## **811 ST. FRANCIS STREET SUBDIVISION**

Engineering Comments: FINAL PLAT COMMENTS (should be addressed prior to submitting the FINAL PLAT for review and/or signature by the City Engineer):

***Revised for the February 2<sup>nd</sup> meeting:***

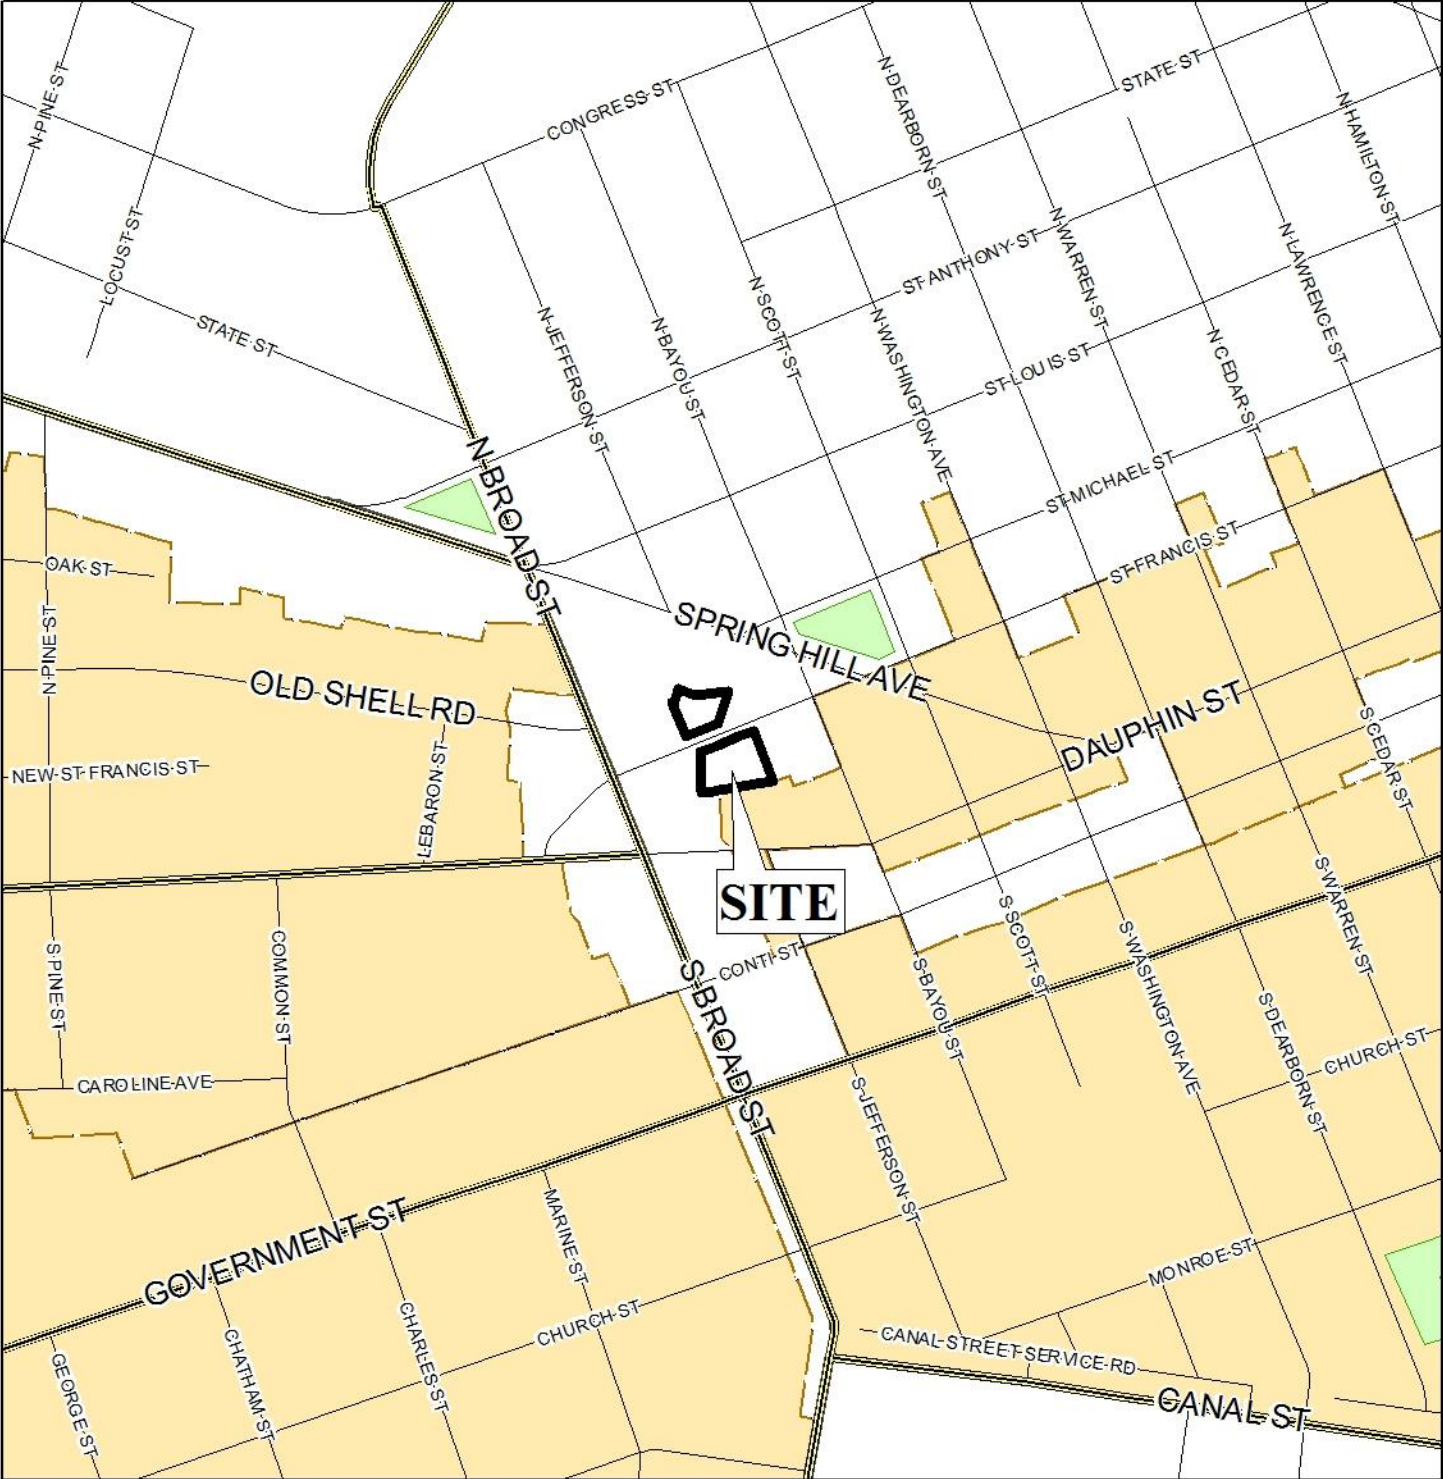
*The previous application was heldover from the January 5<sup>th</sup> meeting at the applicant’s request. The previous application was recommended for approval; however the applicant was not in agreement with all of staff’s recommendations. The applicant would like Lot B to keep the 4 existing curb-cuts to St Francis Street. A site plan and photographs were provided by the applicant to justify the need to keep the existing curb-cuts. Based on the additional information provided it has been determined the existing curb-cuts are needed to allow the site to function effectively and efficiently. Furthermore, it should be noted, there is no new construction being proposed to Lot B thus allowing the existing curb-cuts to be considered “non-conforming”. The applicant should be aware however that at the time of redevelopment or any proposed new construction to the site, the site will be limited to 1 curb-curb with the size, location and design to be approved by Traffic Engineering and conform to AASHTO standards, per Traffic Engineering comments.*

With a waiver of Section of V.D.9. of the Subdivision Regulations, this application is recommended for Tentative Approval subject to the following conditions:

- 1) revision of the Final Plat to depict both lot sizes in square feet and acres, or the furnishing of a table providing that information will be required;

- 2) placement of a note on the Final Plat stating Lot A is limited to one curb-cut, not to exceed 25' in width, as stated in Section 64-3.I.11(c) of the Zoning Ordinance, and Lot B is limited to the 4 existing curb-cuts located on the site, with any changes to the size, design and location to be approved by Traffic Engineering and conform to AASHTO standards.;

- 3) placement of a note on the Final Plat stating at the time of redevelopment or new construction of Lot B, it will be limited to one curb-cut, not to exceed 25' in width, as stated in Section 64-3.I.11(c) of the Zoning Ordinance;
